Treasure Hill

Slope Stability and Fill Comments

Arnie Rusten, PE, SE

11/08/2017

Mid-Station site: Most Visible from Main St.
MPE Section drawing S.2 through Bldg 1B
Excavations of 80'- 140' MAX

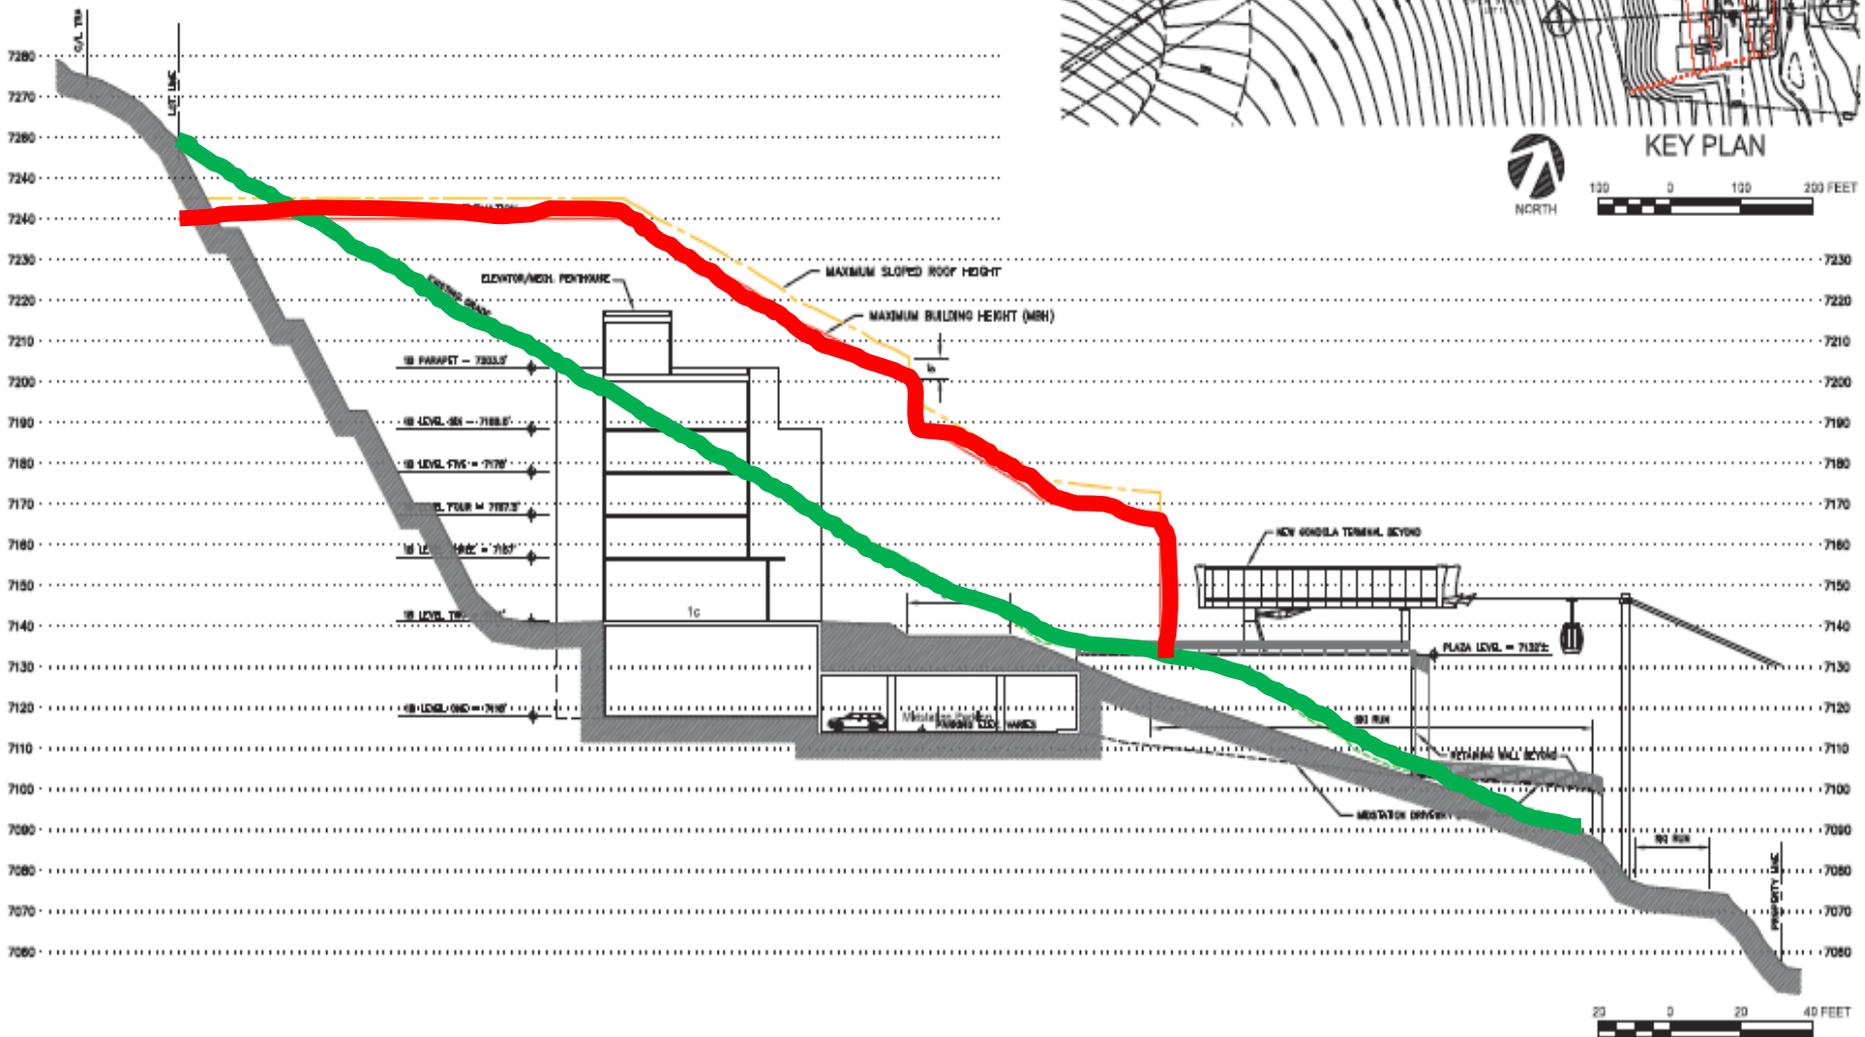
NOTE: what was envisioned in 1985 approval is red between the green & red lines

1.15 MILLION CUBIC YARDS

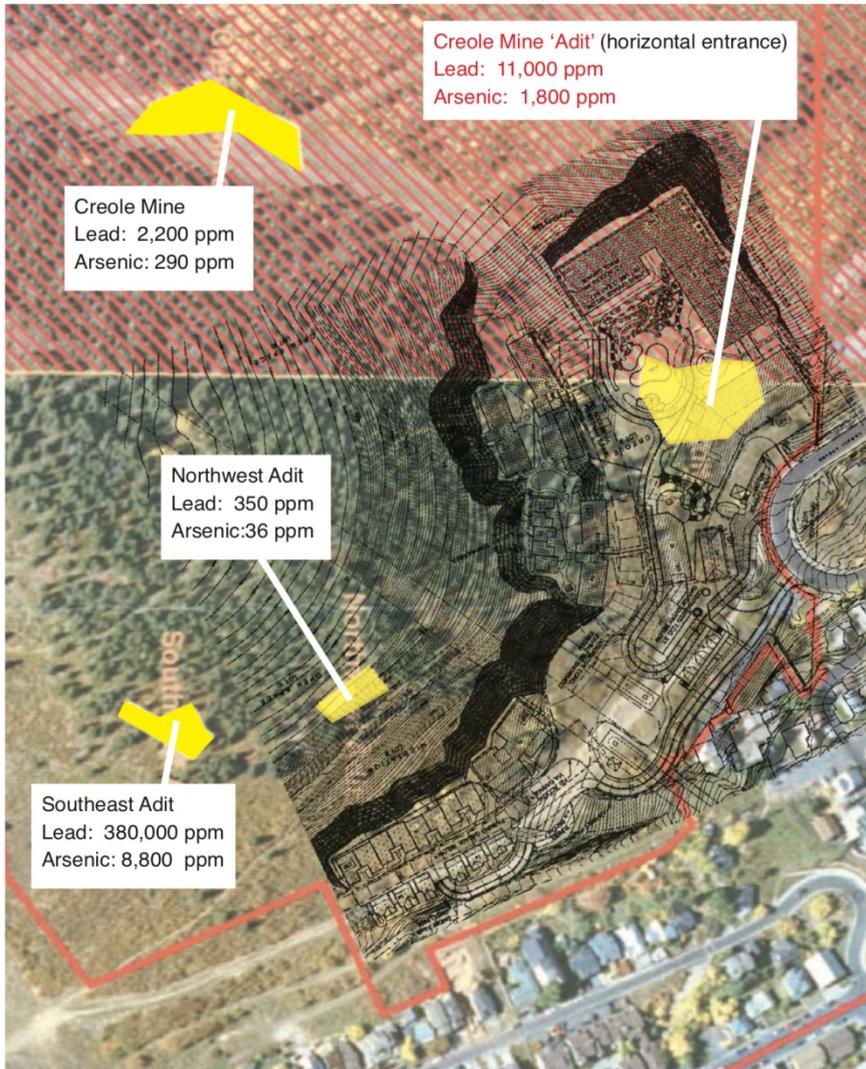
- **NO GEOTECHNICAL INVESTIGATIONS**
- **NO SLOPE STABILITY ANALYSIS**
- **NO DETAILED MATERIAL PLACEMENT PLANS**

1.15 MILLION CUBIC YARDS

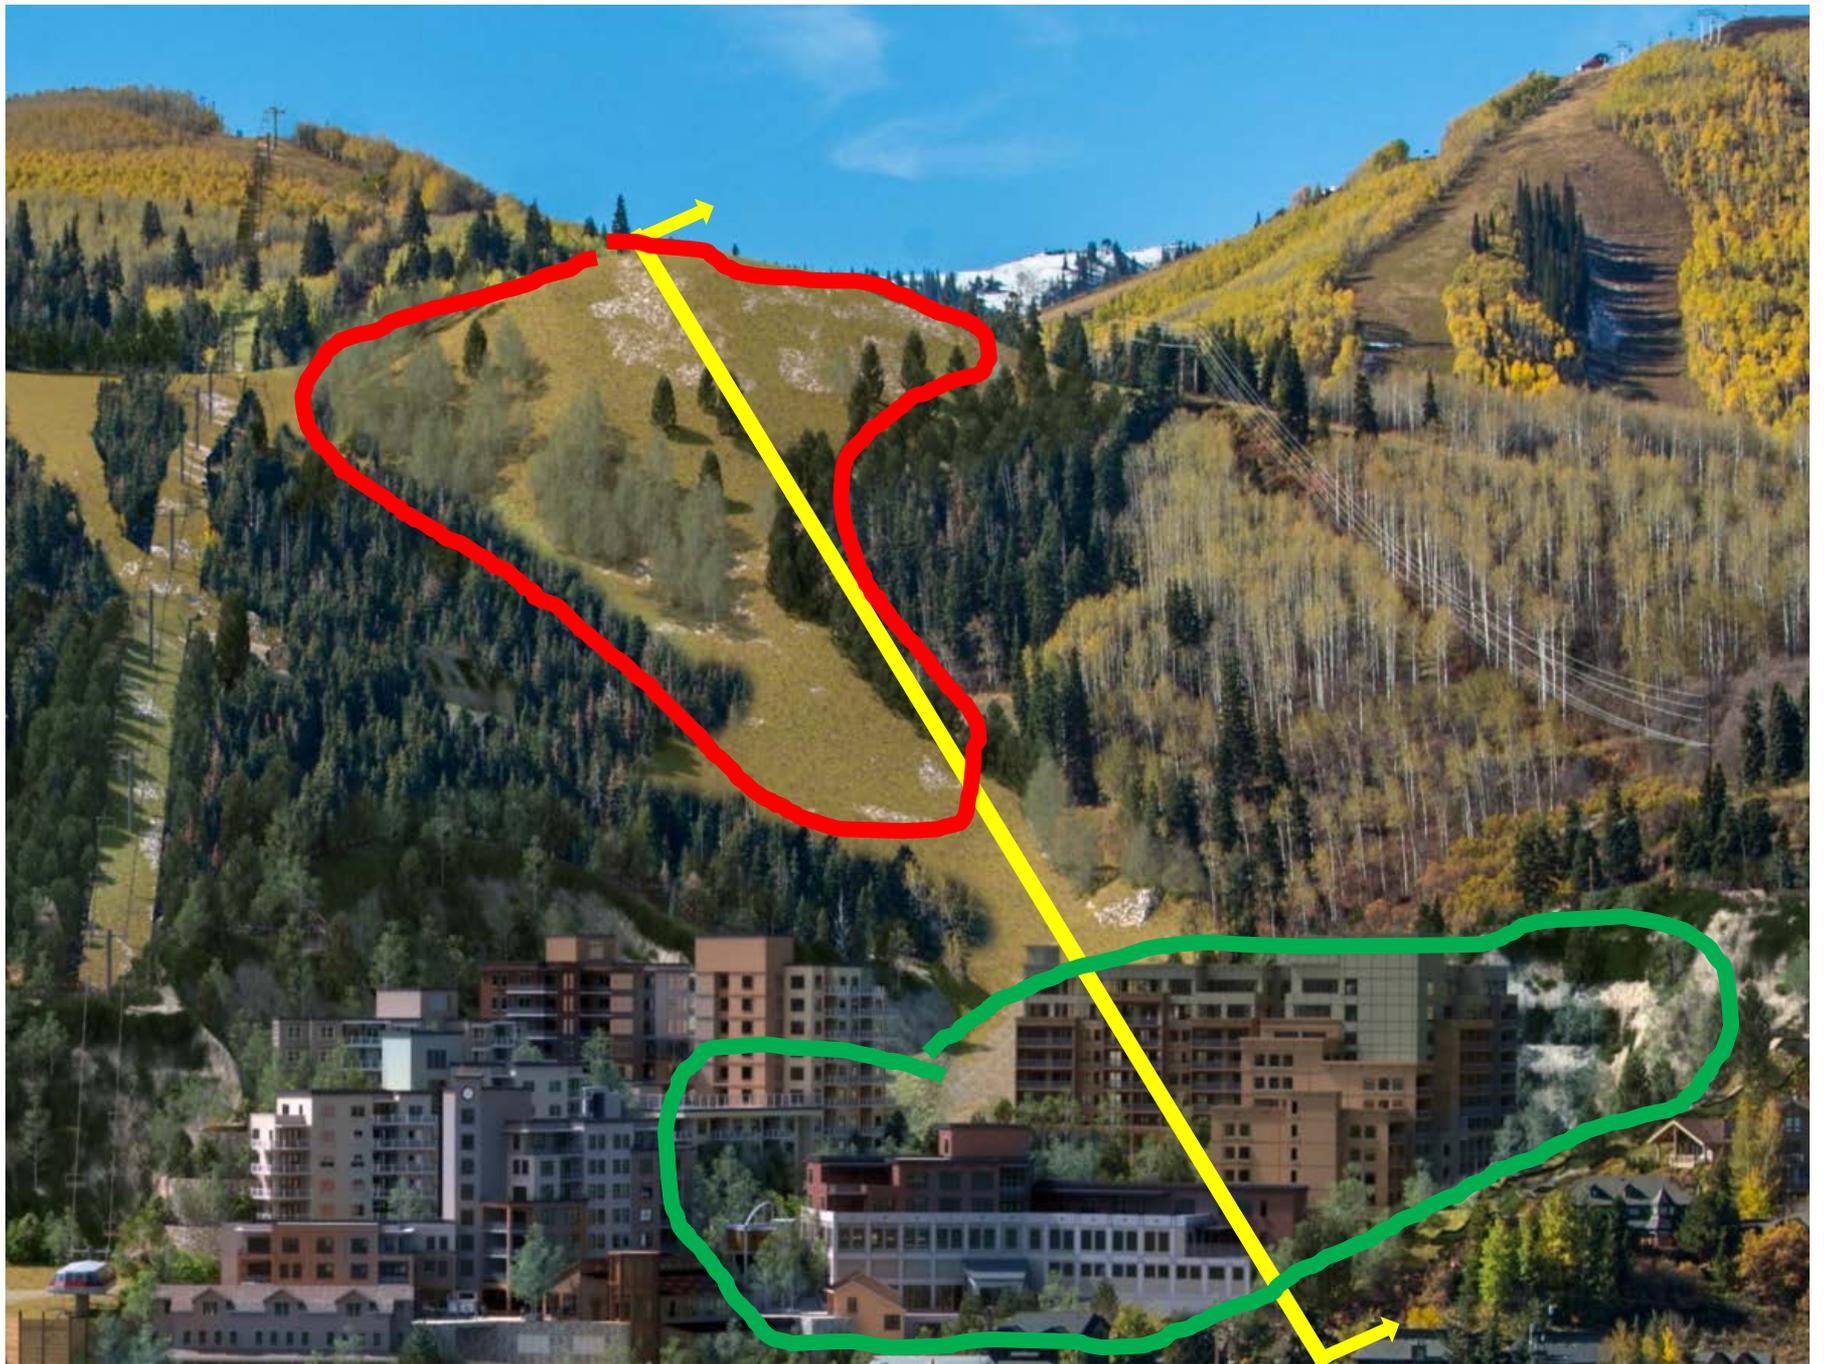
**ROCK VOLUME 1,150,000 CY
ROCK WEIGHT 1,940,000 TONS**

- **REMOVE ALL TREES AND VEGETATION**
- **REMOVE OVERBURDEN SOIL LAYER**
- **STOCKPILE SUITABLE OVERBURDEN (WHERE, HOW)**
- **DISPOSE OF UNSUITABLE OVERBURDEN (WHERE, HOW)**
- **DISPOSE OF CONTAMINATED MATERIAL (WHERE, HOW)**
- **CONSTRUCT ACCESS ROADS**
- **PLACE ROCK FILL**
- **PLACE OVERBURDEN AND REVEGETATE**

SECTION THROUGH CREOLE GULCH

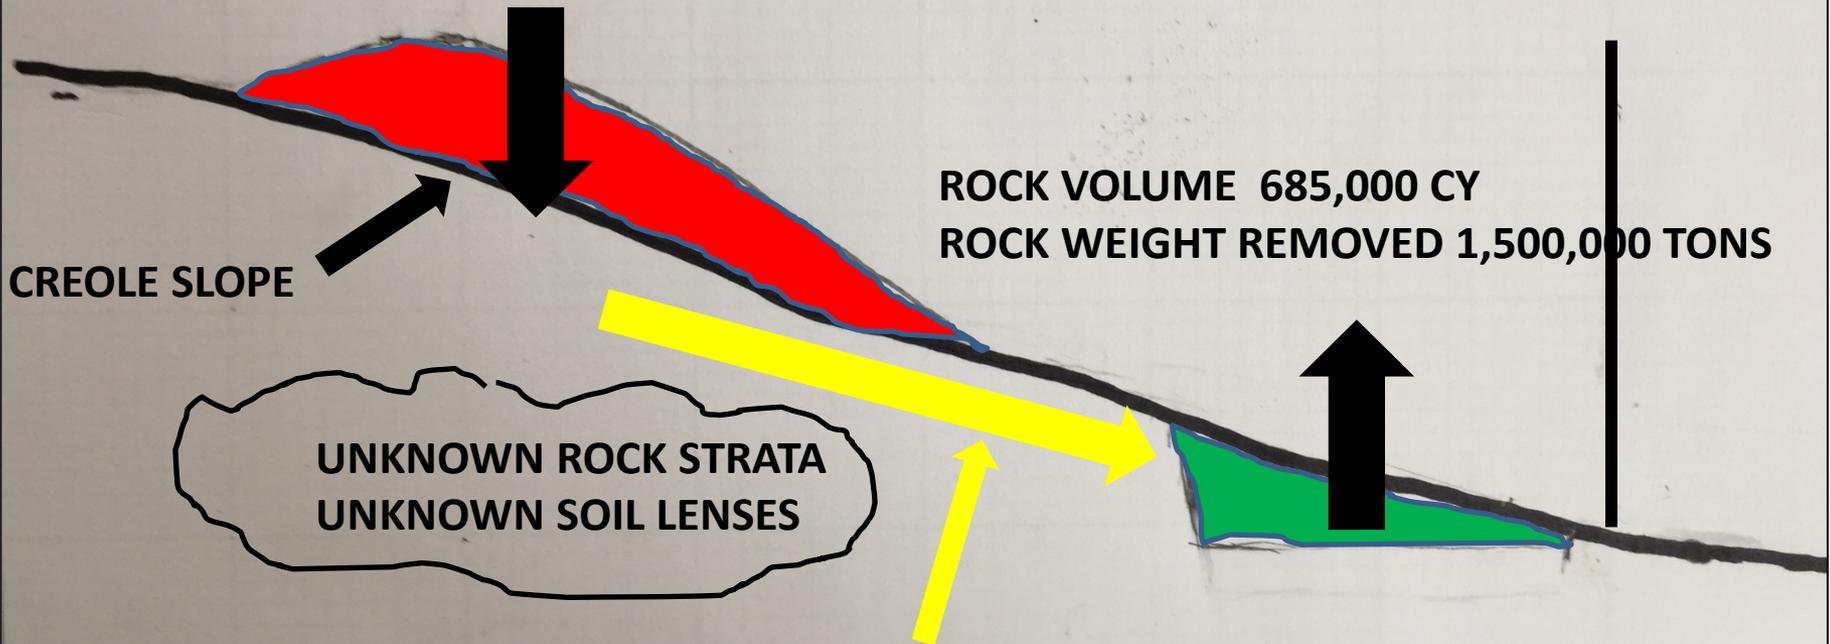
UNKNOWN ROCK STRATA
UNKNOWN SOIL LENSES

POTENTIAL SLIDE
